Subject:- Committee to review reconstruction work of Malabar Hill Reservoir.

Final report of the Committee for review of the Malabar Hill Reservoir.

FINAL REPORT OF THE COMMITTEE FOR REVIEW OF MALABAR HILL RESERVOIR

FINAL REPORT OF THE COMMITTEE FOR REVIEW OF MALABAR HILL RESERVOIR

Figure 5.1. Inflow and outflow pattern of MHR (data Source: BMC)

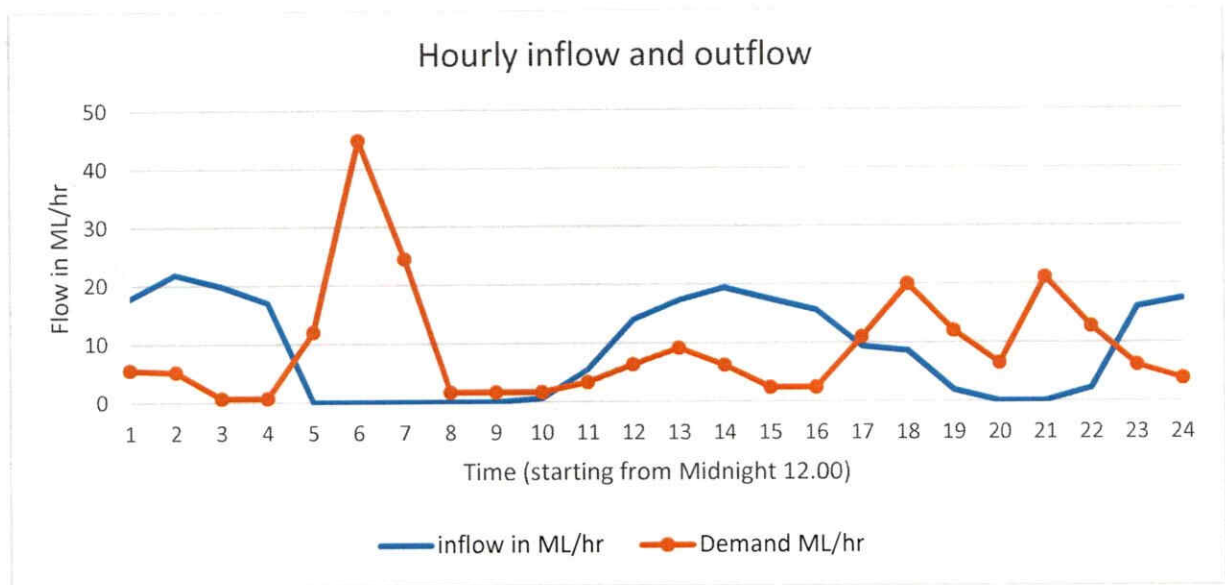
From Figure 5.1, it is seen that the inflow pattern follows two cycles per day, starting from the previous day's night 9.00 pm to the current day 5.00 am, and then again from 10.00 am to 8.00 pm, with no inflow from 5.00 am to 10.00 am. The peak inflow is at 2.00 am and 2.00 pm during the first and second cycles, respectively.

From Figure 5.1, it can be seen that the outflow is continuous throughout the day and has two high outflow cycles: the first cycle starts from 4.00 am to 8.00 am, and the second cycle starts from 10.00 am to the next day at 3.00 am with multiple peaks. This is due to the staggered outflow operations of multiple outlets.

- i. If there is any change in the inflow and outflow patterns, there will be a disturbance in the supply of water across the zones served by MHR.
- ii. These patterns are linked with the supply reservoir (MBR) of the Bhandup water treatment plant and the demand for drinking water from various zones served by MHR.

Figure 5.2. The mass curve of cumulative inflow and outflow of MHR

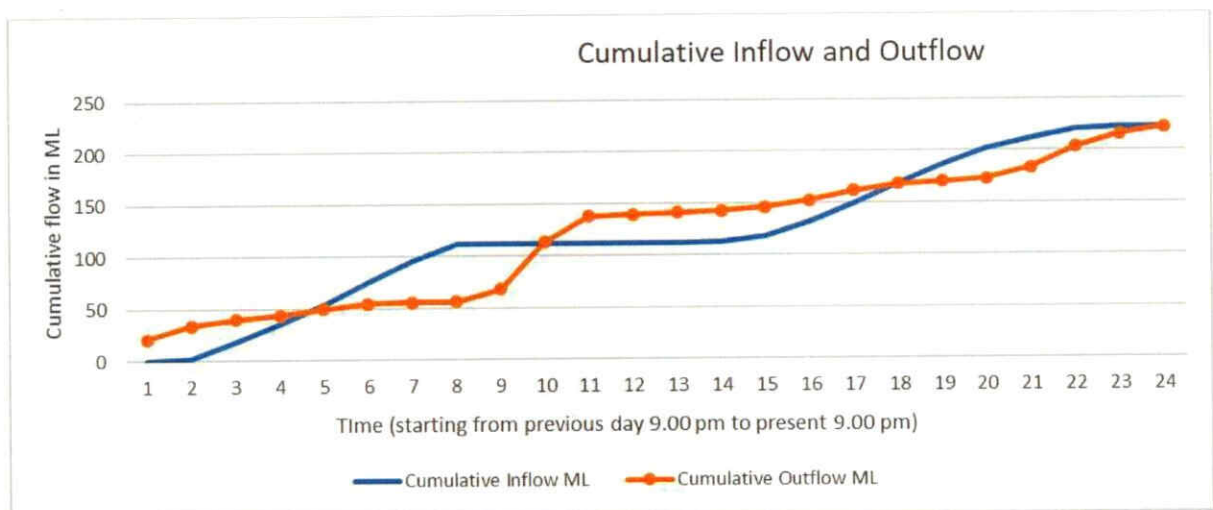
The usable storage capacity required for the present inflow and outflow patterns is estimated using the double mass curve technique as per CPHEEO (2023, Part A). The double mass curve drawn for MHR with an operational period of one day (i.e., the operational inflow-outflow cycle repeats every 24 hours), is given in Figure 5.2. From Figure 5.2, the maximum surplus in a day and the maximum deficit in a day account for the required usable storage of MHR. Based on the CPHEEO recommendations, the required usable storage of MHR for the given inflow and outflow patterns is given in Table 5.1.

Based on the above method, the usable storage capacity required in MHR for the present inflow and outflow patterns = 56.04+31.75 = **87.79 ML**

As per the present inflow and outflow patterns, MHR requires a usable capacity of **87.79 ML** to meet the demand. From the given hydraulic particulars of the MHR provided by BMC, it is seen that the present usable capacity is 74.52 ML, which concludes that the present usable storage capacity is a deficit capacity to the tune of **13.27 ML**.

It is concluded that while designing the alternative storage tank, this deficit of **13.27 ML** usable capacity shall be added to make the distribution of water even to the far-end people served by MHR.

**Thus, the usable storage capacity of the alternative tank =
39.17+13.27=52.44 ML**

Hence, based on the data made available to the committee and subsequent double mass curve calculations, the required usable storage capacity of the alternative tank shall be **52.44 ML**.
